ADVISORY NOTICE

Since issuing the previous COBRA guidance note DB500-PGN-2, JFD have been working on improving the flow capacity of the hot water relief valve on the COBRA set.

Figure 1 - Hot water relief valve

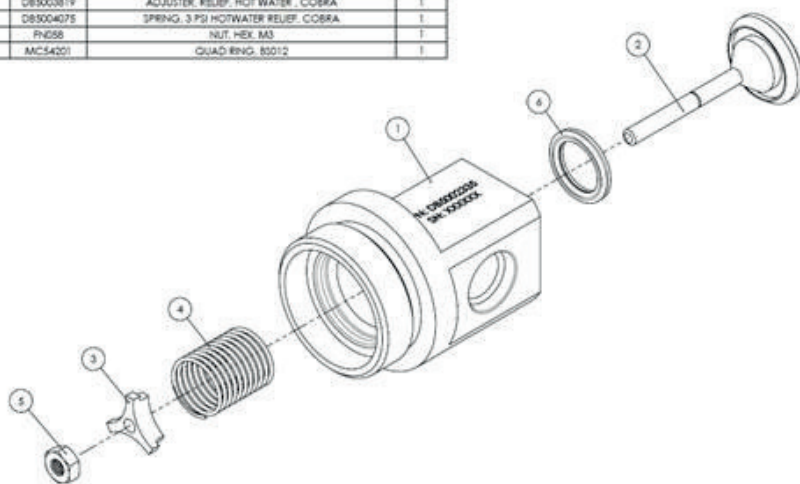
During a recent investigation into a COBRA set which experienced water ingress into the scrubber, it was identified that the existing PRV could not vent the full amount of water diverted to the COBRA set by the splitter block (approx. 3 L/min), whilst limiting the pressure rise within the water jacket to an acceptable value. This would only be necessary in the very unlikely event of a full blockage of the COBRA hot water outlet.

JFD have supplied a replacement PRV spring and spring retainer / adjuster. This will enable the PRV to open further for the same pressure rise and will limit the pressure within the water jacket to 5 psi in the case of full blockage of the hot water outlet. Replacement components are being free-issued to all COBRA users, and this guidance note provides instructions on how to fit these items.

- Remove locknut (item 5) and retain
- Remove items 3 and 4 and discard
- Fit new spring (part number DB5004075) and new adjuster (part number DB5003819)
- Re-fit the locknut to the piston (item2) but do not tighten

- See Figure 1
- Hold the stem (item 2) and turn the adjuster (item 3) clockwise to increase the set pressure or anticlockwise to decrease the set pressure, then retest.
- When 3psi +/- 0.2 psi has been achieved, tighten the locknut (item 5) against the adjuster, ensuring components are locked together.
- Confirm set pressure has not changed.
- Remove test equipment and re-fit relief valve to set.

Figure 2 - Test equipment

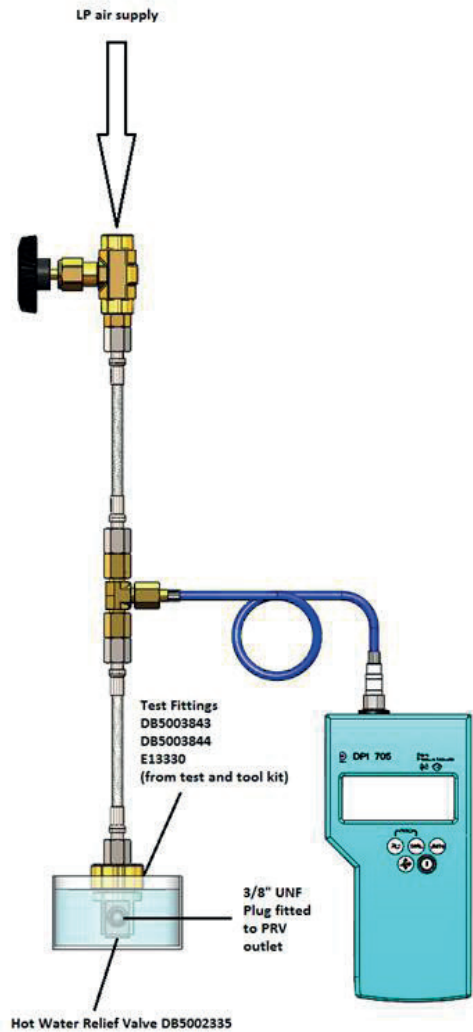
- Fit the test plug (DB5003843), test nut (DB5003844) and o-ring (E13330) to the hot water relief valve DB5002335 as shown in figure 1. These items are contained in the COBRA Tool and Test Kit. Fit a 3/8" UNF plug to the outlet of the relief valve
- Connect an LP air supply and a calibrated LP gauge. Care should be taken when applying pressure if a very low range gauge is used until it is confirmed the PRV will vent correctly.

NOTE: Ensure that the 3/8" plug does not interfere with the spring inside the PRV. It may be preferable to fit the Hot Water Inlet Hose from the COBRA set (which has a specially shortened 3/8" fitting) and fit a 9/16" UNF blank to the other end of this hose.

- Immerse the hot water relief valve in water (minimum depth to cover relief outlet)
- Gently apply air pressure to the relief valve inlet and note the pressure reading when bubbles start to form in the water

NOTE: The reading is taken when the first bubbles begin to form. Any appreciable flow through the PRV will cause a higher reading on the gauge due to the port size on the test fitting.
